PROPOSED MANAGED FILL

300 RIVERVIEW ROAD, HUNTLY

ASSESSMENT OF NOISE EFFECTS

Gleeson Managed Fill Limited Resource Consent Application (LUC0233/20)

Figure 2. Managed Fill Zoning, Operative District Plan

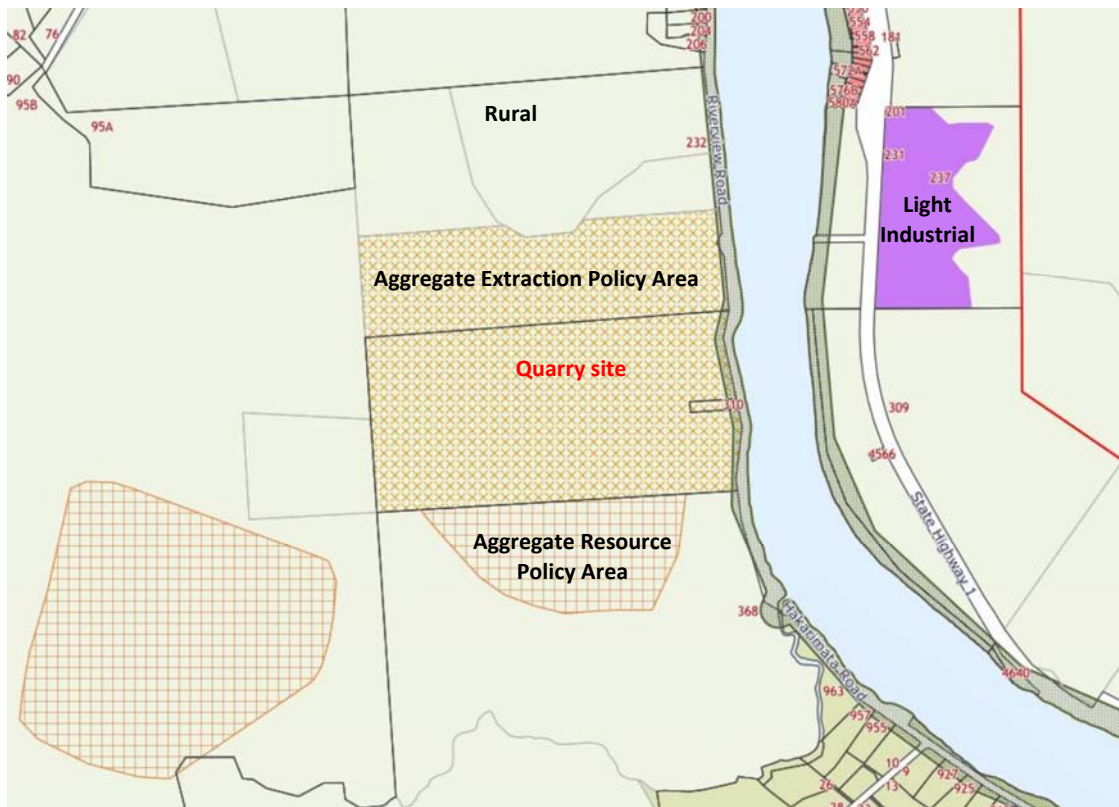
- a) The activity is separate to the quarry operation;*
- b) The activity will be located closer to neighbouring dwellings.*
- c) Section 16 requires the best practicable option of noise management to be applied.*
- d) The fill areas are located within the Rural Zone and not the Aggregate Extraction Policy Area*

Checking Figure 10 (the location of the proposed fill sites) in the original noise assessment against Figure 2 (the Operative District Plan Zoning map) shows the southern part of the Fill 2 area and Fill 5 area are located within the Aggregate Extraction Policy Area. It is agreed the northern area of Fill 2, Fill 3 and Fill 5 areas are in the Rural Zone.

Figure 1. Measured noise opposite 70 Hillside Heights Road

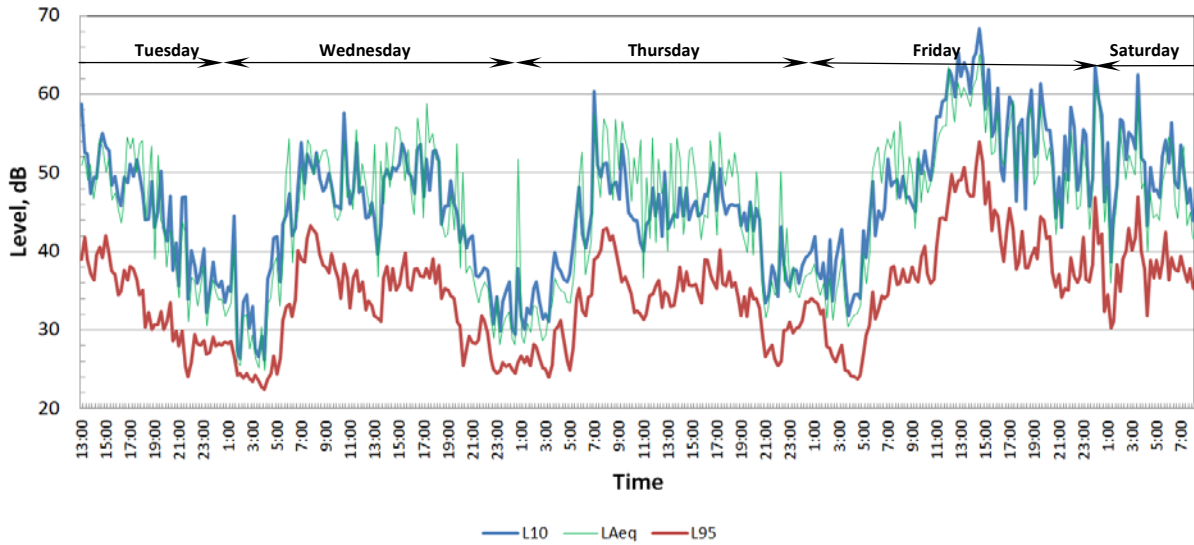
Predicted noise levels at the closest houses on the western side of the Waikato River (i.e. away from SH1) are around 35dB LA10, which is similar to existing noise levels for 70 Hillside Road. Please provide the LAeq measurement in the same graph (i.e. LAeq and LA90 or L95) in section 3 of the Acoustic Report

Figures 1 and 2 show the noise levels for L10, LAeq and L95 opposite 70 Hillside Heights Road and 206 Riverview Road respectively. The LA90 was initially plotted as well but there was no distinguishable difference to the L95 so in not included on the graphs.
